PREVOST

SAFETY RECALL

SR23-304

DATE :	June 2023	SECTION :	18 BODY
SUBJECT:	Missing Weld on Passenger Flip-Up Seat

FLIP-UP SEAT FRAME

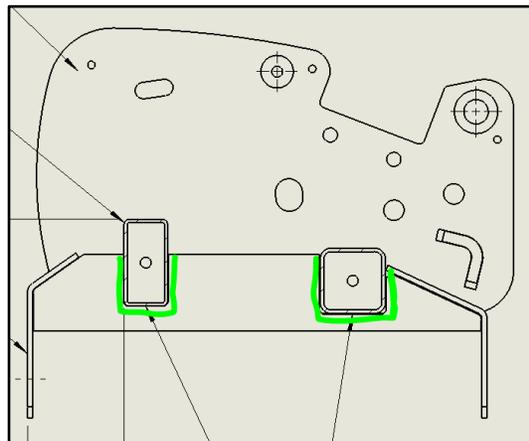
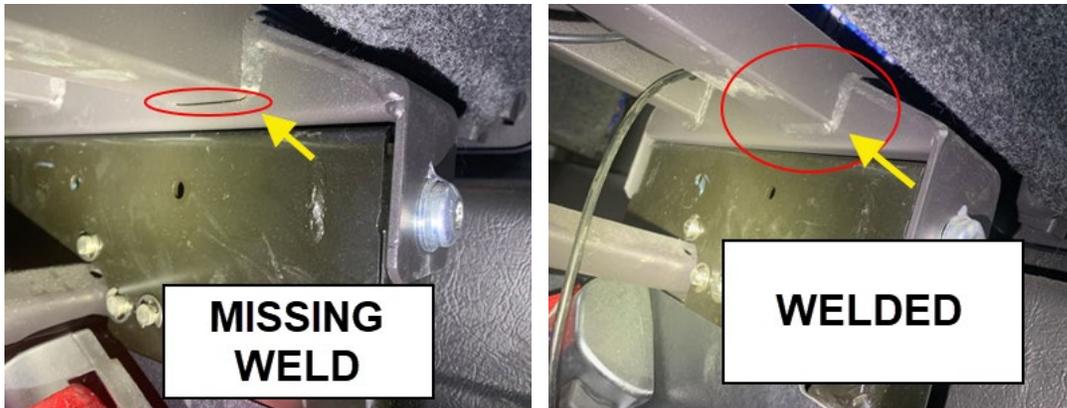
On the vehicles affected by this recall, some of the foldable passenger seat frames may have been improperly welded.

Therefore, all vehicles must have their folding seats inspected and their frames replaced as necessary following the inspection procedure provided below.

- 1. The tubes, brackets, and center pivot are to be welded as shown below in blue. The weld will be on both sides of the recline bracket and center pivot.

2. The tubes and brackets are to be welded as shown below in green. The weld will be on both sides of the pedestal brackets.
